Ref: 211108.L.002
24 March 2022

Re: Gas Membrane Validation – Drama Block, Belle Vue Coop Academy

Enclosure I - Drawings

Enclosure 2 – Photographs

Visit 2 – 8 March 2022

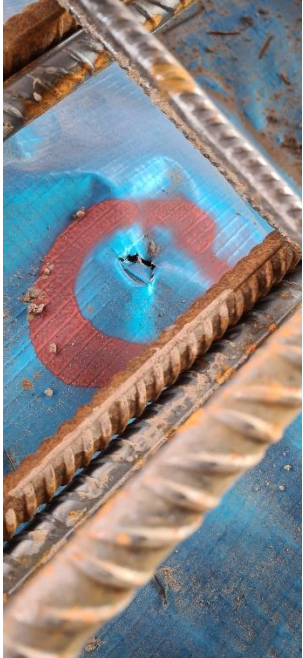
4.	View of the dowel holes within the gas membrane, awaiting sealing with Axiom.	
5.	View of the stanchions confirming the Visqueen design has been followed accordingly.	
6.	View of ongoing work, showing sealed dowel entries on the left and centre of the site and to be sealed entries on the right.

Visit 3 – 16 March 2022

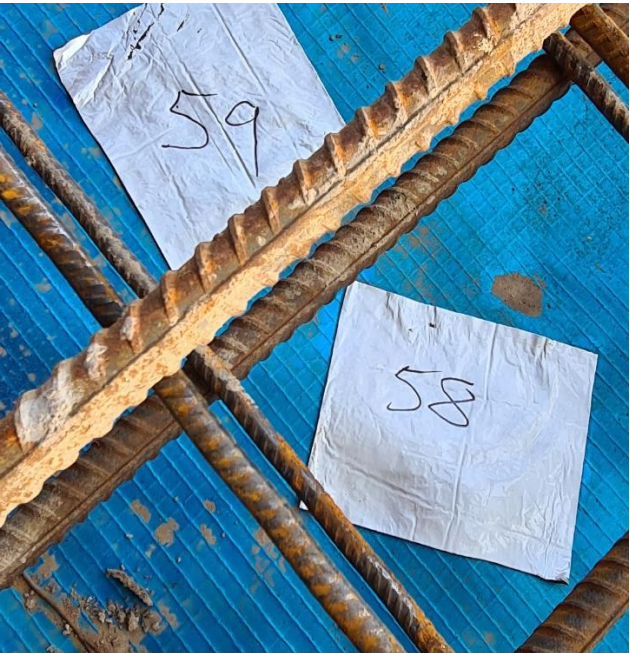
7.	View confirming Visqueen membrane installation across the entire footprint of the plot (beneath the steel works).	
8.	Damage caused to membrane (1 of 59 identified during the site visit).	
9.	View confirming Visqueen membrane installation across the entire footprint of the plot (beneath the steel works).

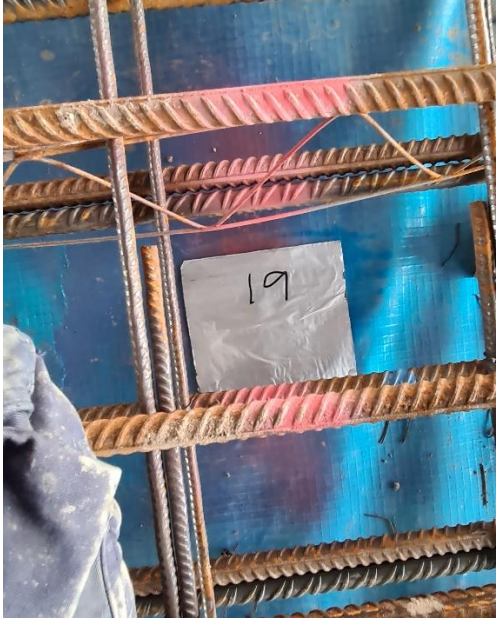
10.	Repair of damage caused by follow-on steel works (31 of 59).	
11.	Repair of damage caused by follow-on steel works (58 and 59 of 59).	
12.	Repair of damage caused by follow-on steel works (16 and 17 of 59)

13.	Repair of damage caused by follow-on steel works (46 and 47 of 59)	
14.	Repair of damage caused by follow-on steel works (1 of 59)

15.	Repair of damage caused by follow-on steel works (19 of 59)	
16.	View of damage caused by follow-on steel works (20 of 59)	
17.	View of damage caused by follow-on steel works (39 of 59)
